PMcL/3167D5/SA1 Response

**NEW ROAD DEVELOPMENT
A259 NEW ROAD, RUSTINGTON,
LITTLEHAMPTON**

S278 HIGHWAY ACCESS WORKS

**Road Safety Audit Designer's Response
STAGE 1**

Figure 7/12 : Major/Minor Priority Junction with Nearside Auxiliary Lane (para 7.56)

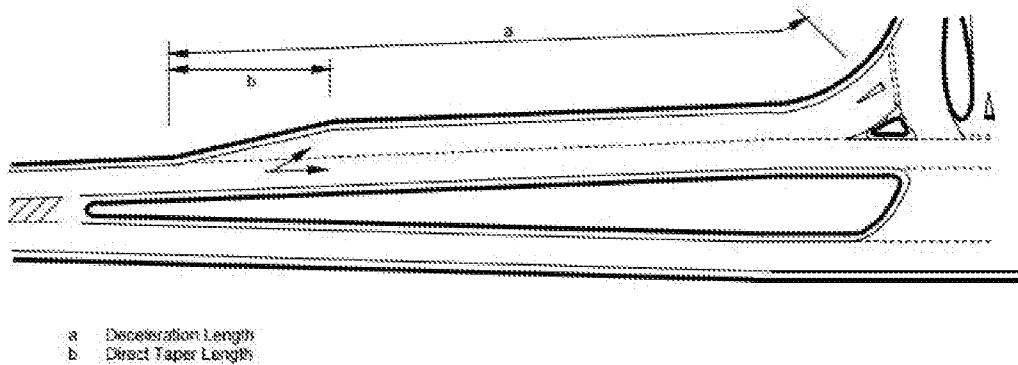
Problem - Inadequate weaving length

It was apparent from the site visit, that the recently constructed acceleration lane associated with the adjacent development, to the east, merges with the A259 channel line approximately 40 metres to the east of the proposed deceleration lane. Therefore, vehicles exiting the adjacent development will be in conflict with vehicles entering the proposed development which are likely to be changing lanes simultaneously. This may result in side swipes and shunts along the recently constructed acceleration lane where vehicles are not able to merge onto the A259 from the adjacent development

Recommendation: It is recommended that the weaving length is increased appropriately.

RESPONSE: Traffic leaving the adjacent development will have to give way to traffic travelling along the nearside lane of the A259. Due to site constraints, the entry radius to the site is restricted to 20 metres. Figure 7/12 of TD42/95 (extract below) shows the

required length of the deceleration lane as dimension 'a'. At the end of the deceleration lane Figure 7/12 indicates a give way triangle indicating that the entry radius into the site is not a speed reducing feature as the radius is beyond the give way lines:

The 'weaving length', i.e. the distance between the point at which the adjacent site's merge lane joins the A259 New Road and the start of the taper for the proposed development has been increased to 90 metres. We have amended the deceleration length to accord with a required distance 'a' of 110 metres for a Design Speed of 120kph as specified in Table 7/5b of TD42/95 (extract below):
